SUBJECT: 08V-448 SAFETY RECALL NOTIFICATION

Sr08-12

DATE : OCTOBER 2008	SECTION : 23-ACCESSORIES
SUBJECT : REPLACING WEAKENED BOLTS ON THE ROOF ESCAPE HATCH

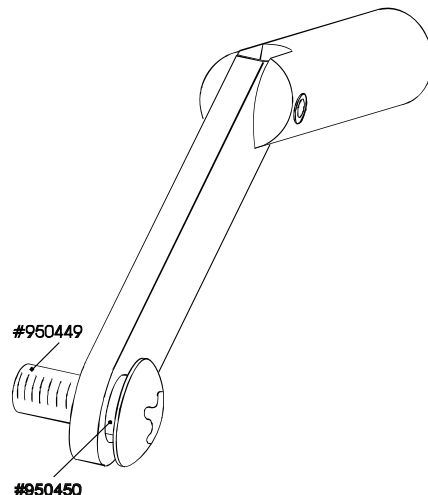
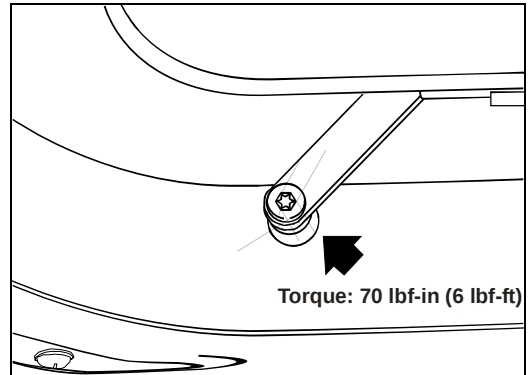
4. Insert the new bolt #950449 into the bushing #950450.
5. Insert the bolt and bushing into the hole in the linkage. Hand tighten the bolt into the threaded brass insert.
6. Tighten new bolt and bushing to a torque of **70 lbf·in (6 lbf·ft)**. Use a screwdriver bit Torx T40. Loctite is not needed for the new installation.

When tightening the bolt, hold the linkage over the bushing and against the head to ensure correct alignment.
